Technical Service Bulletin: tsb100682

Released Date: 24-Mar-2008

New CELECT™ Fuel Pump

Old CELECT™ Fuel Pump (Part Number 4010324) and New CELECT™ 2.0 Fuel Pump (Part Number 4954880)

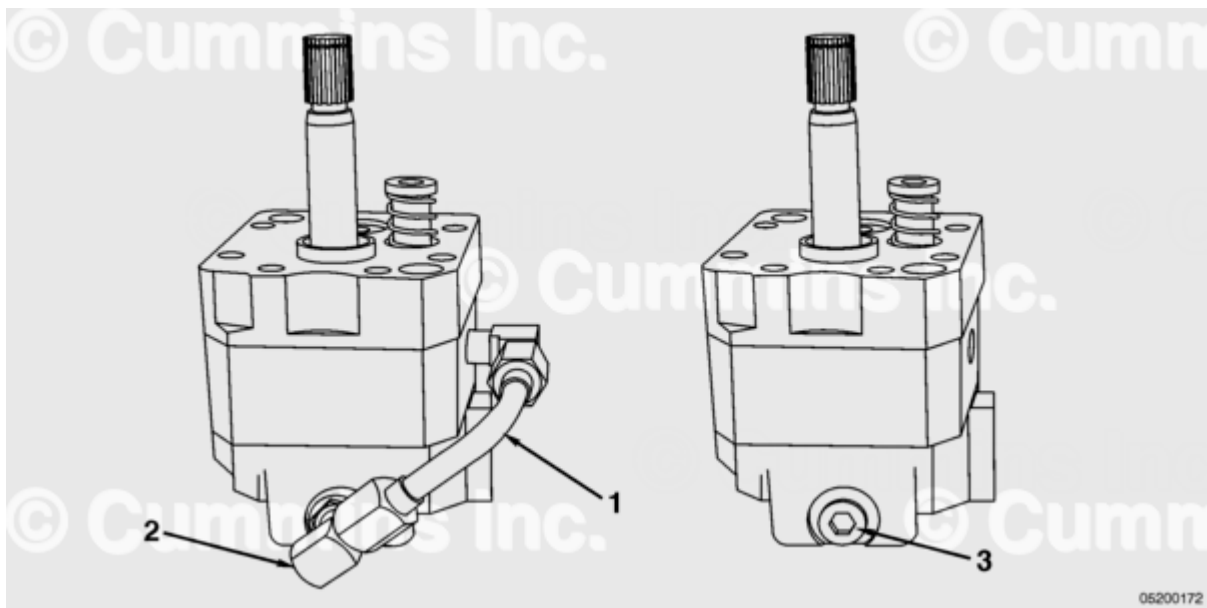
Previous CELECT™ fuel pumps have included an external fuel cooling tube. The redesigned pump will no longer contain this external fuel cooling tube. This new fuel pump is being released for all N14, L10, M11, ISM, ISMe, and QSM engines as a new part and replaces all previous parts. The old design fuel pump with the external cooling tube will still be available as a remanufactured item. The new CELECT™ 2.0 fuel pump, Part Number 4954880, supersedes Part Number 4010324 and Part Number 4010253. Refer to the figures below for the differences between the new CELECT™ 2.0 fuel pump and the old CELECT™ fuel pump.

1. Tube, cooling
2. Valve, check
3. Plugged Port (No cooling tube)

Old CELECT™ Fuel Pump (Part Number 4010324) and New CELECT™ 2.0 Fuel Pump (Part Number 4954880)

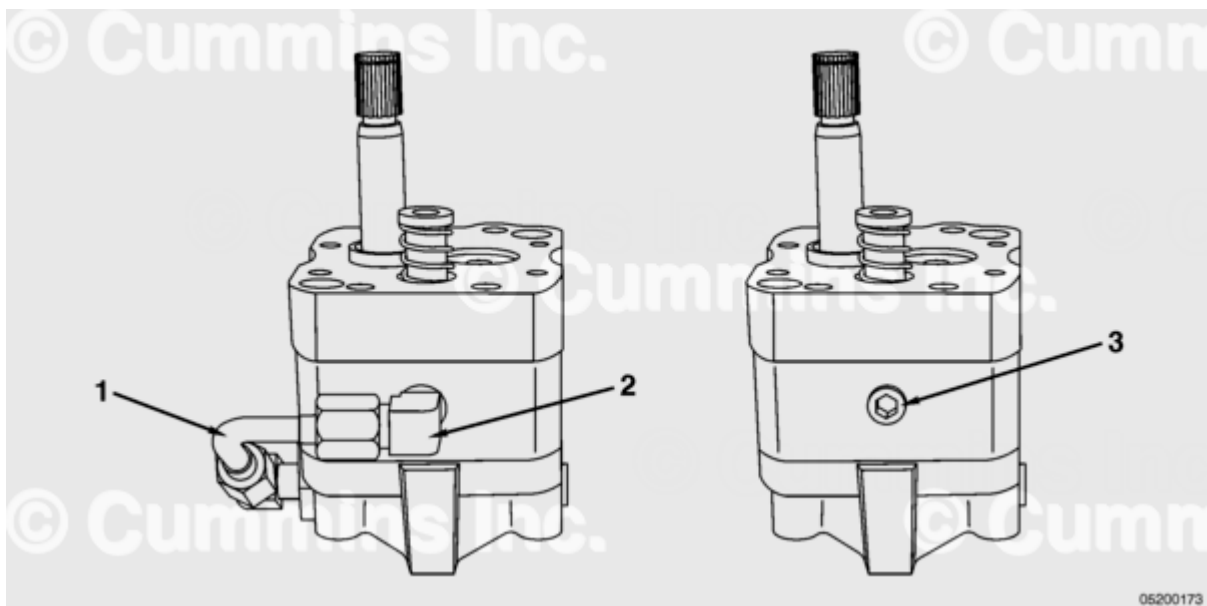
1. Tube, cooling
2. Fitting, elbow
3. New production fuel pump will **not** have this drilling.
